**CHANGE ORDER FORM**

Change Order No. 01  
Project Title KWRU Filter & CCC Replacement  
Bid No. 02  
Owner: Key West Resort Utilities Corp.  
Contractor: Wharton Smith  
Agreement Date: 4/18/ 2018

Re: Change Order Proposal No. 01 Revision 1  
KWRU Filter Replacement  
Generator Replacement

# KWRU WWTP GENERATOR REPLACEMENT

**3**  
D-01

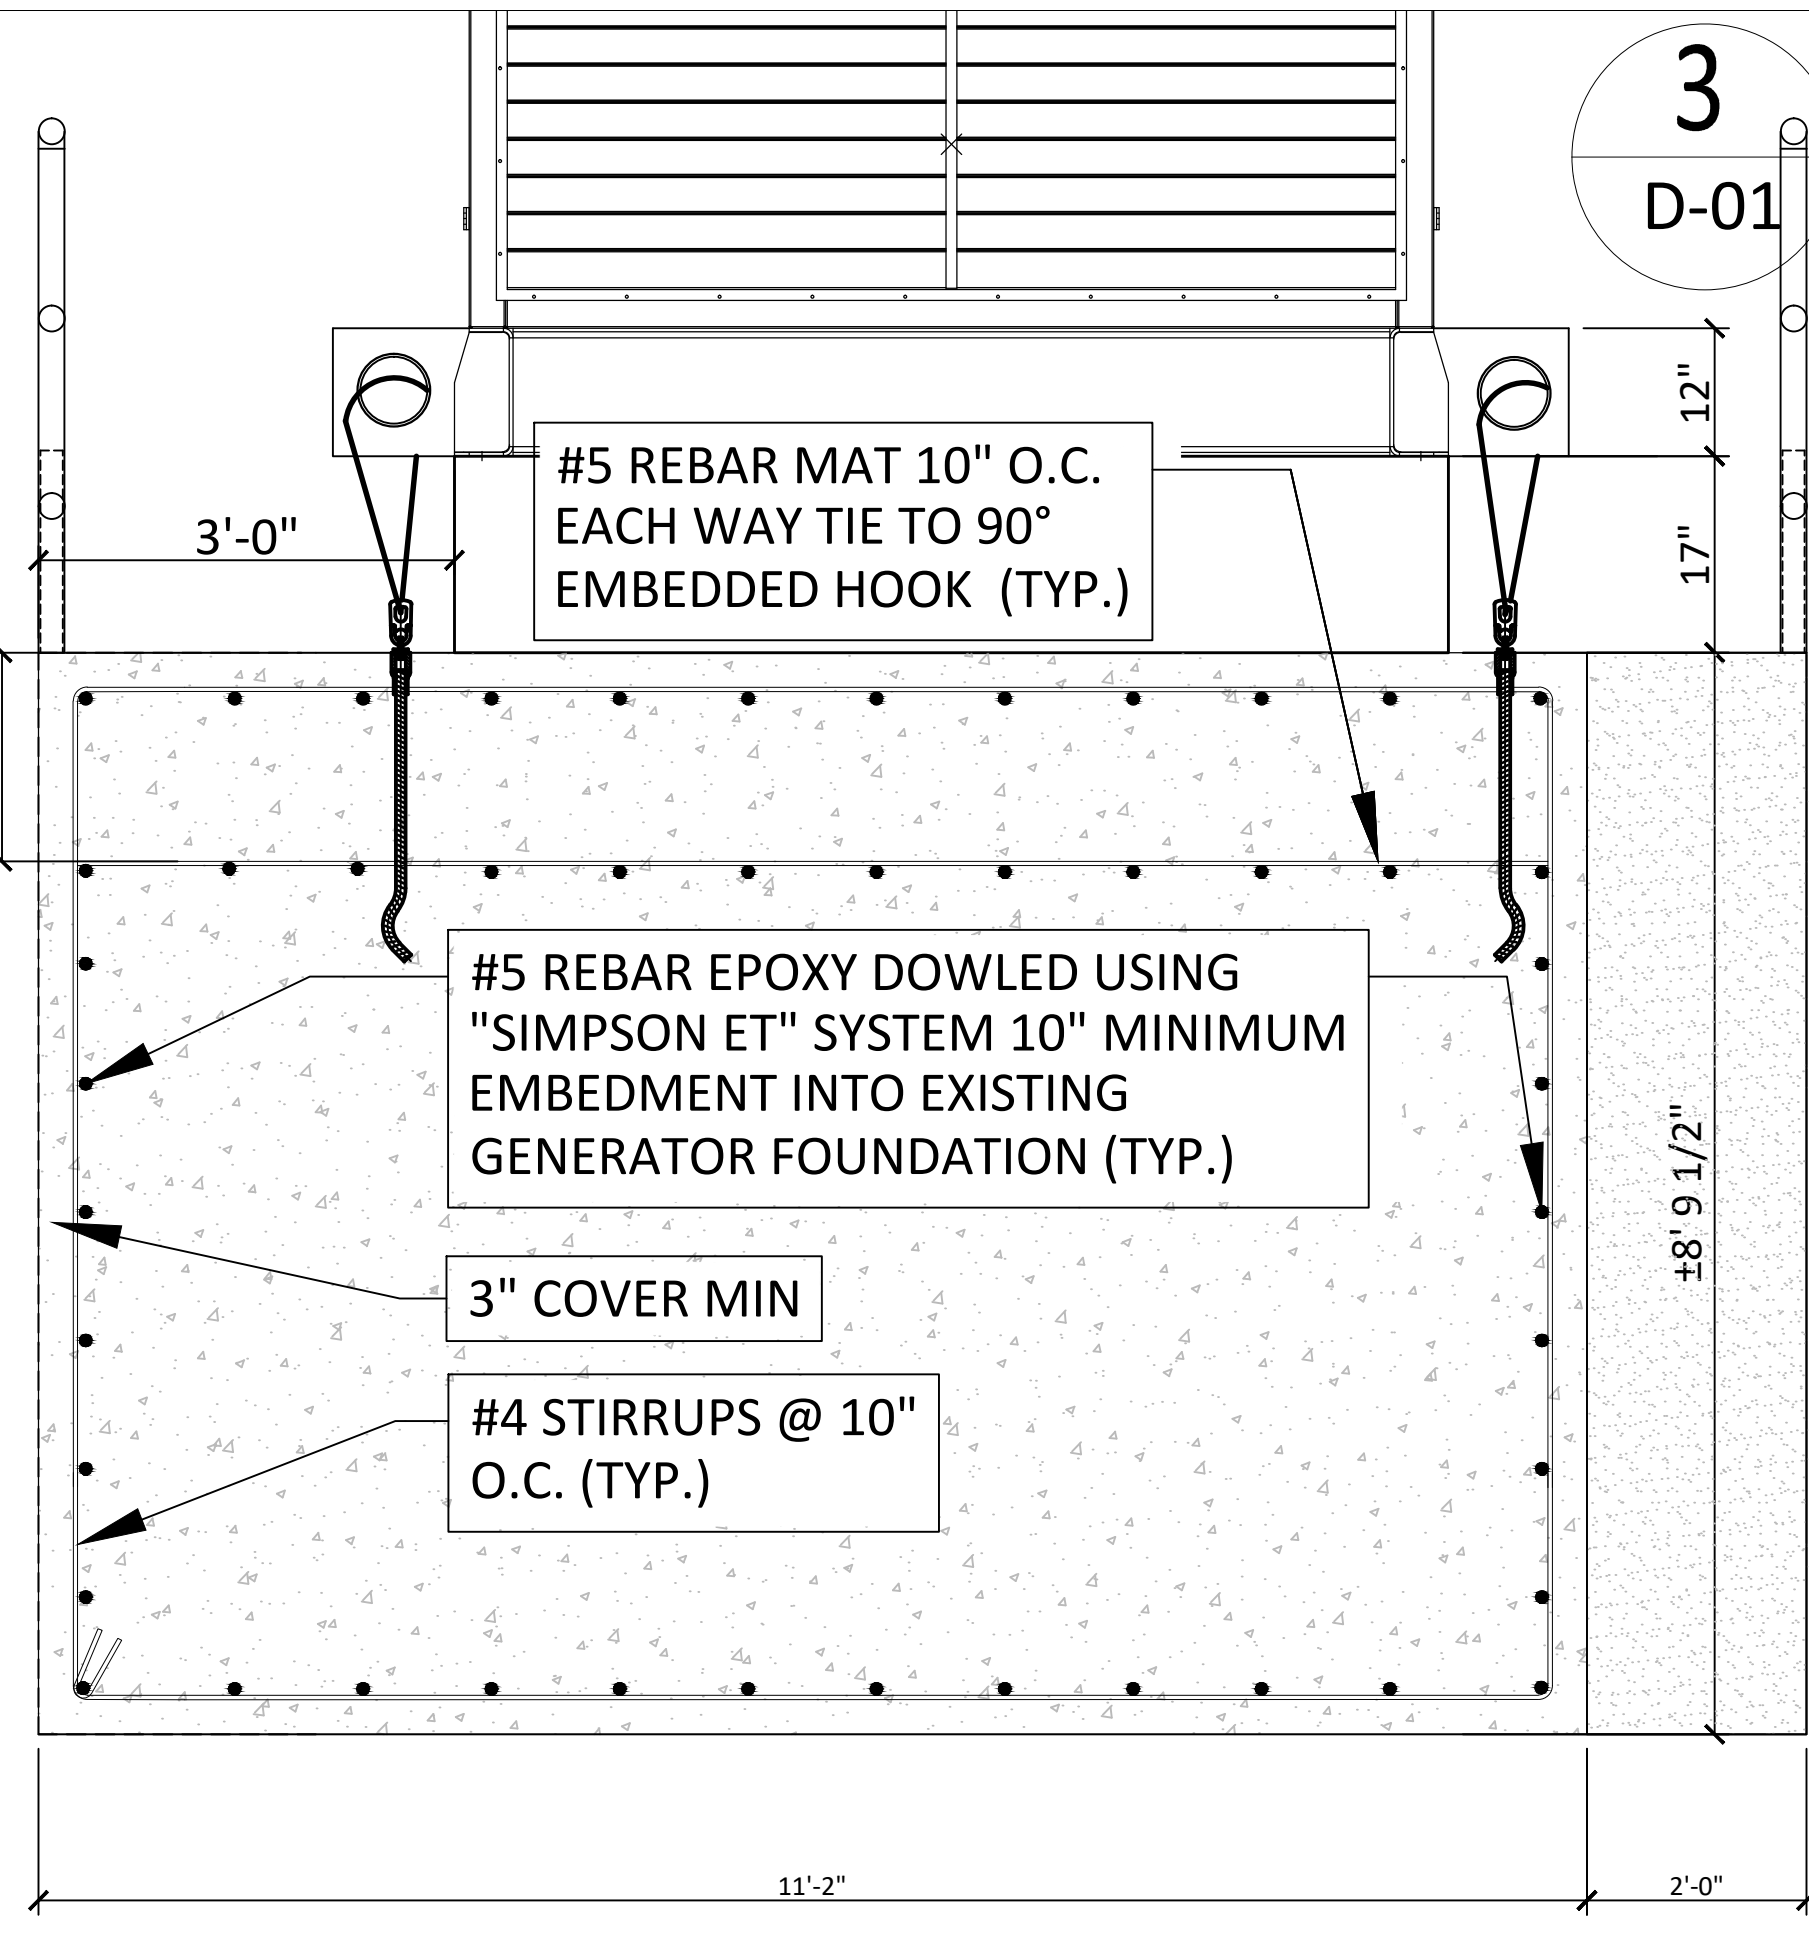
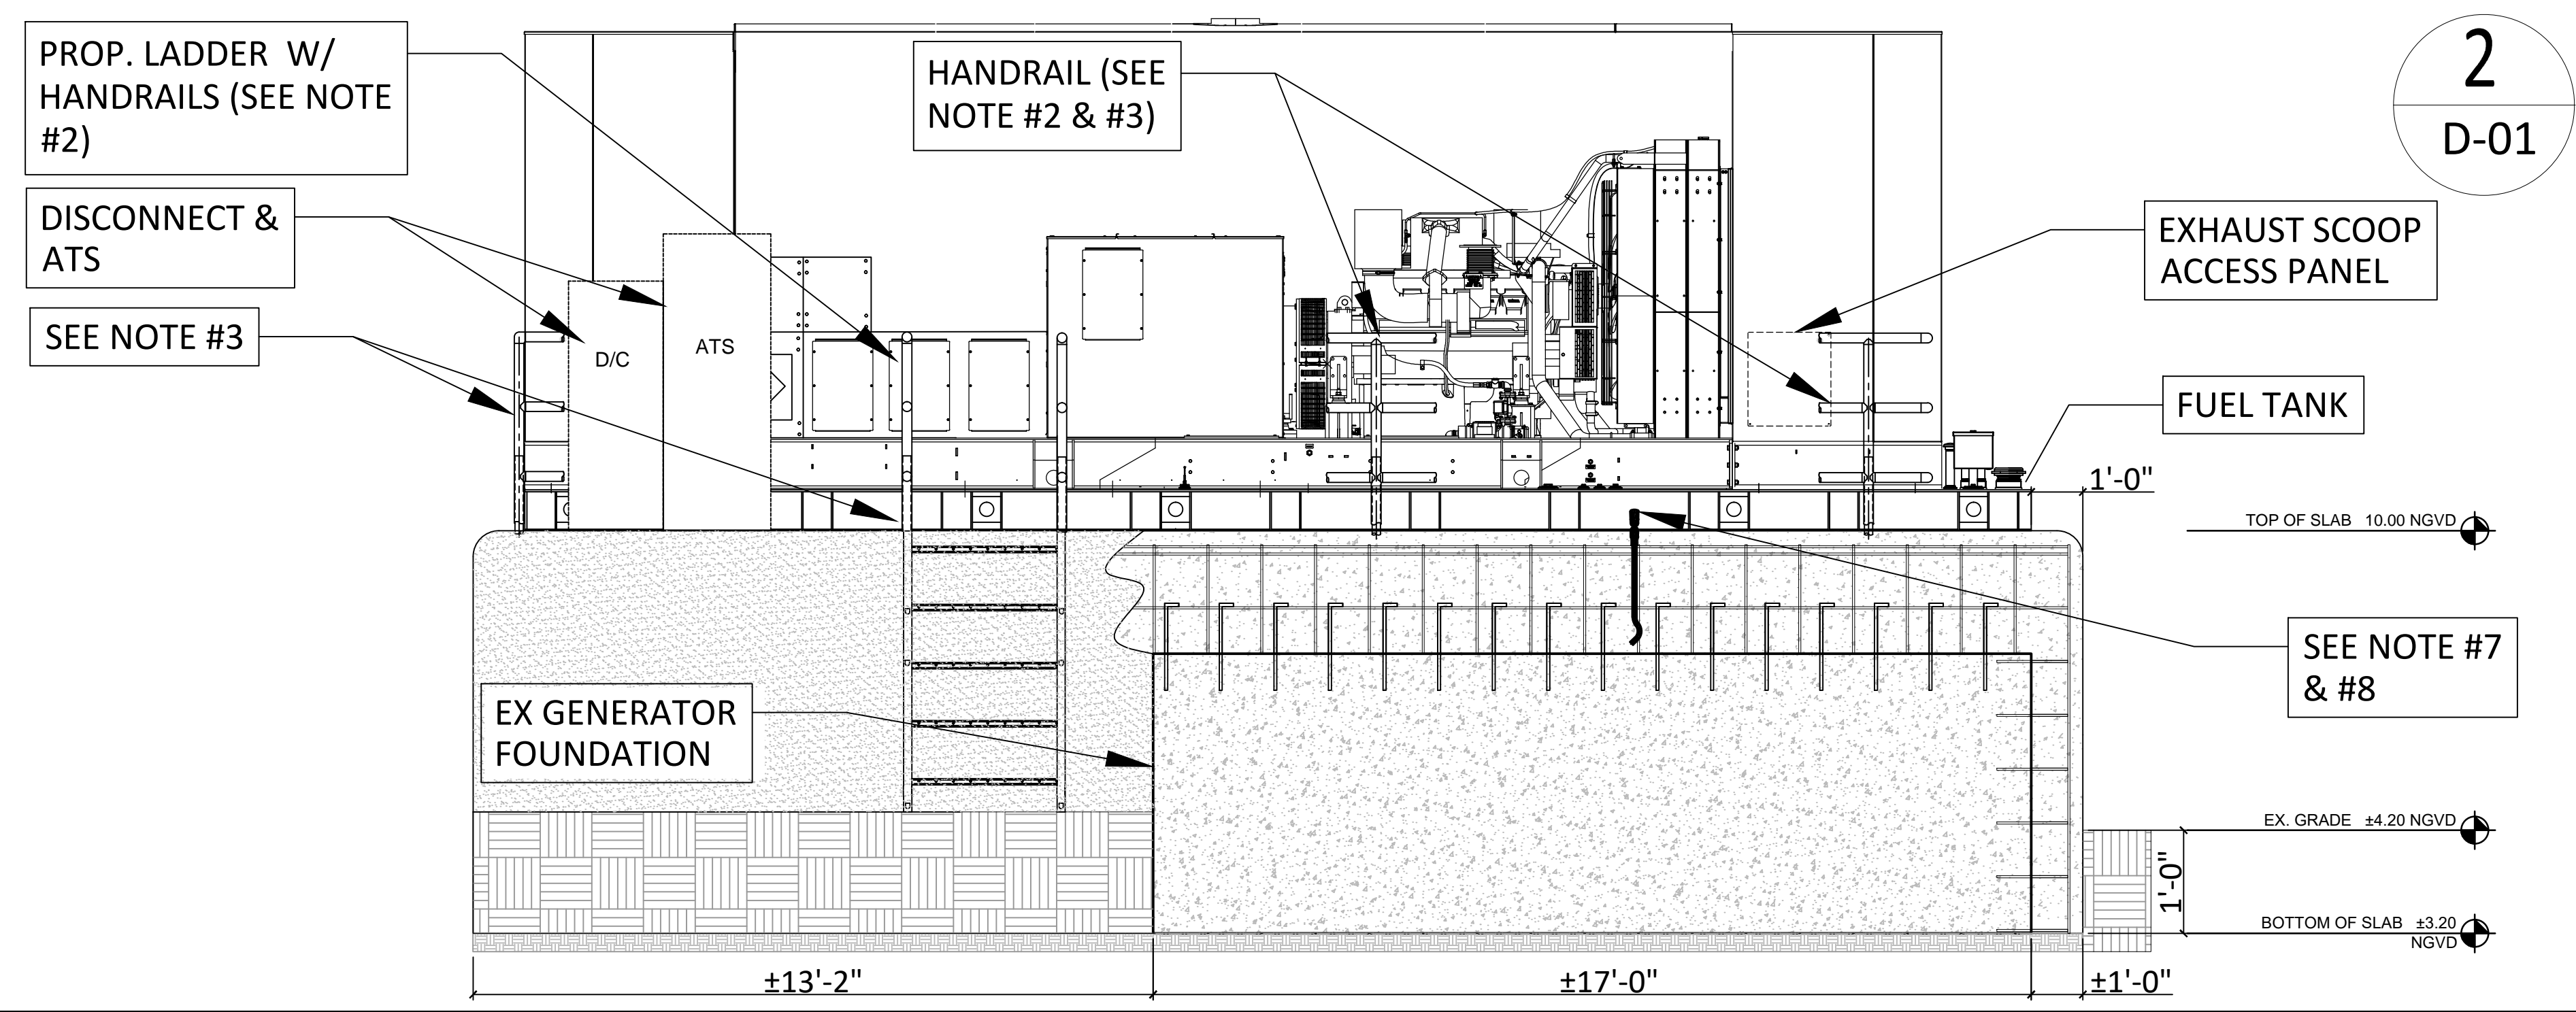
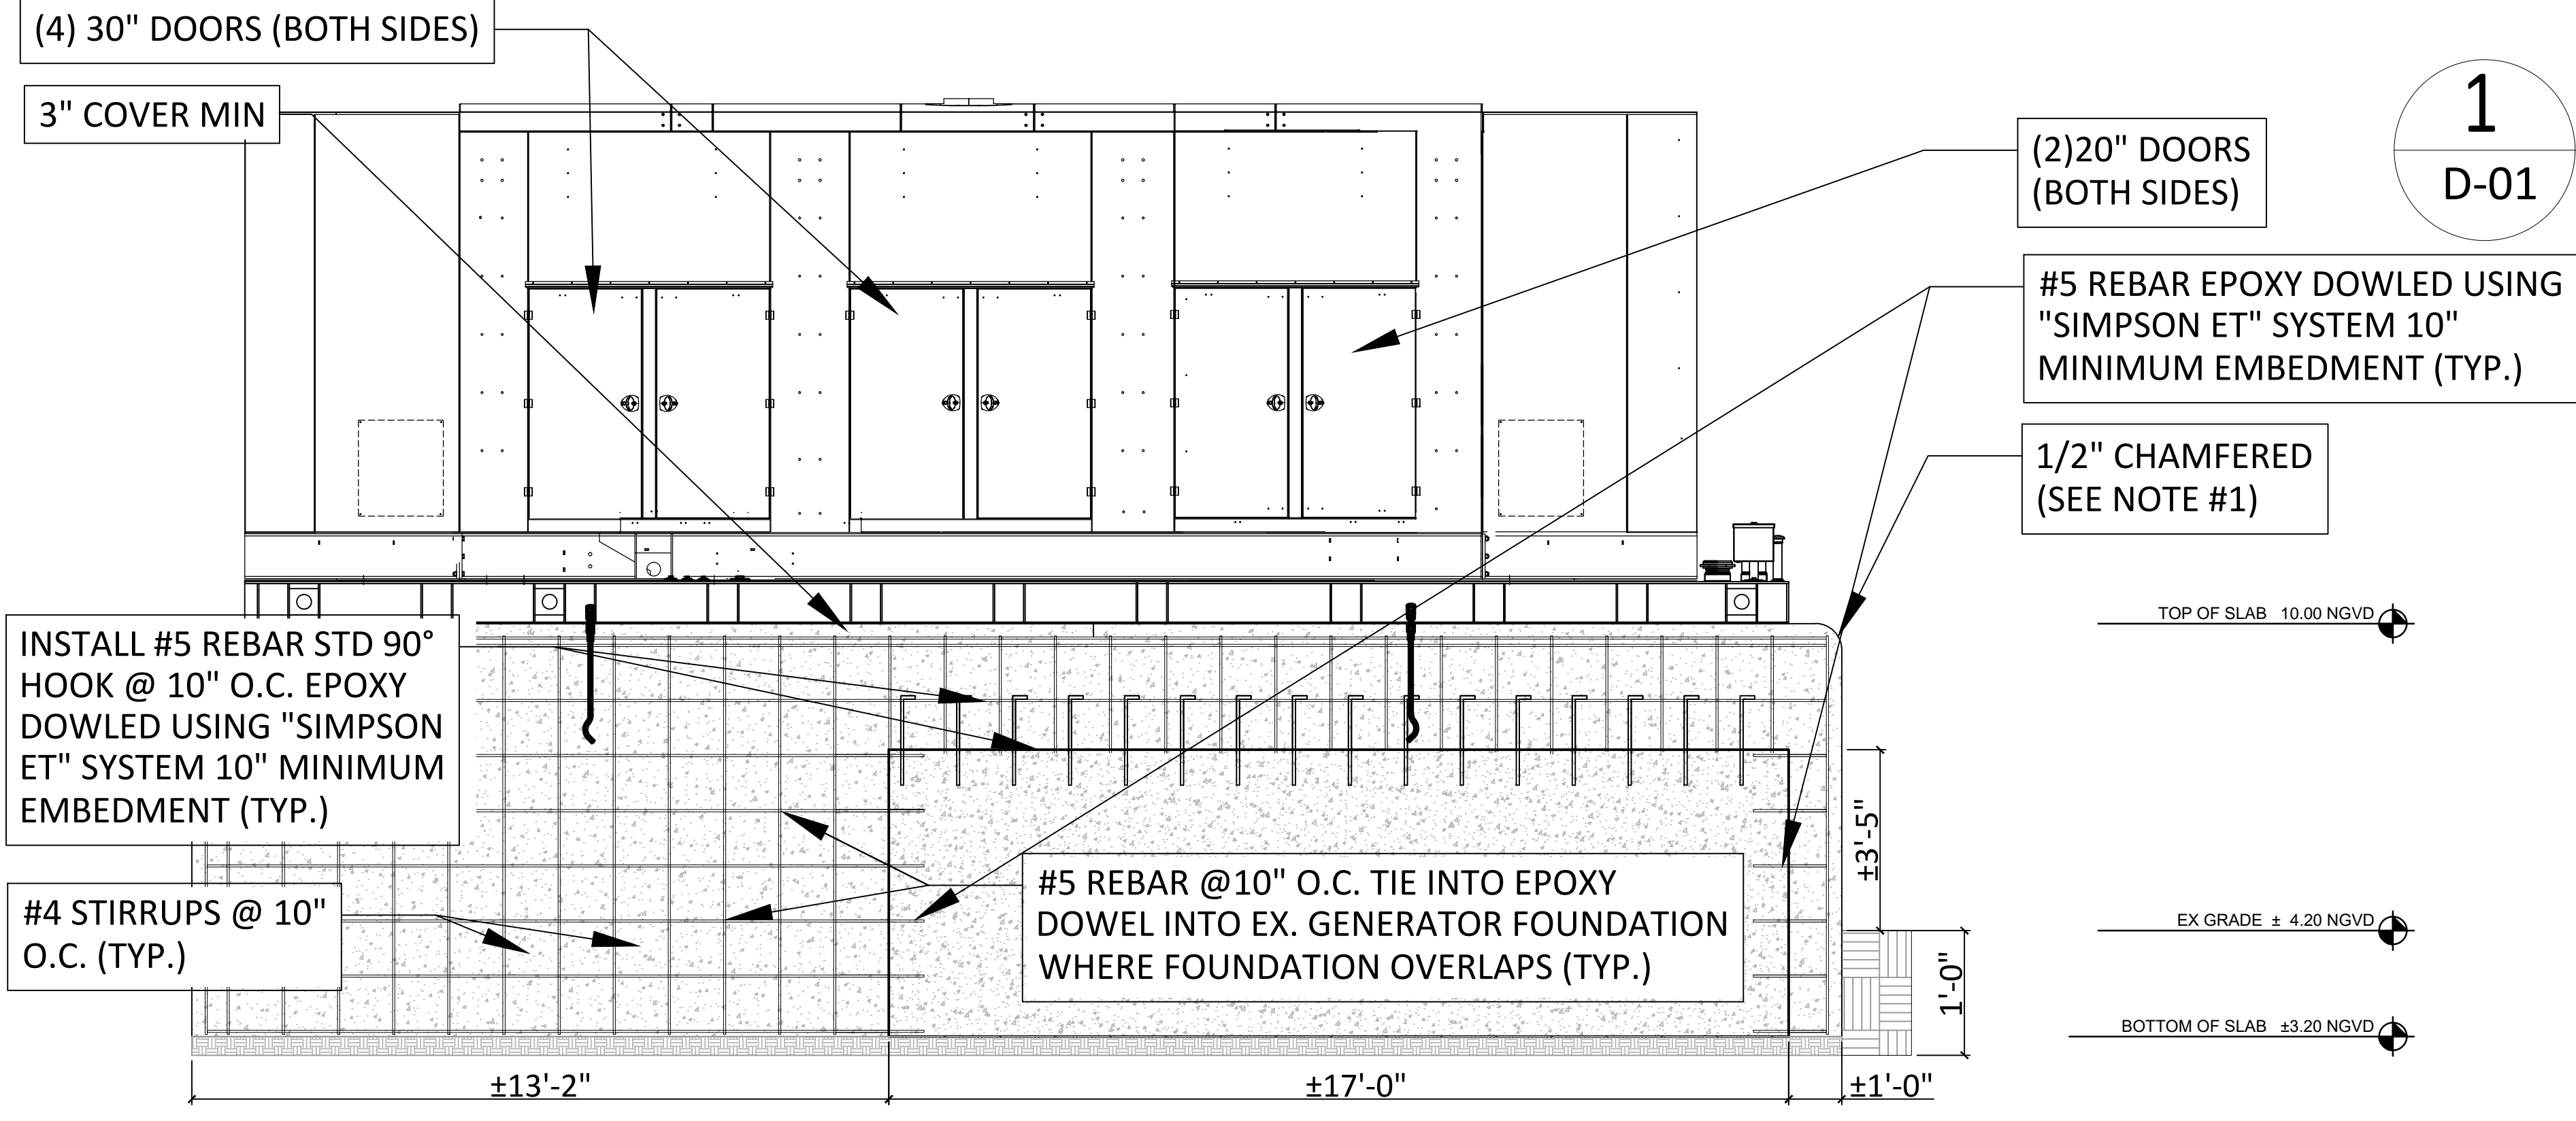
- Installation of modified generator foundation as shown and described in the attached plans.
- Coordinate delivery with Generator supplier and offloading of generator from freight shipper.

- Setting & installation of generator on modified foundation as shown in attached plans.
- Underlayment (like what is proposed for the filters) shall be installed between generator fuel tank and concrete.

- Supply and installation of generator tie-downs as shown on the attached plans including all misc. hardware.
- Installation of aluminum handrail as shown in the attached PDF.
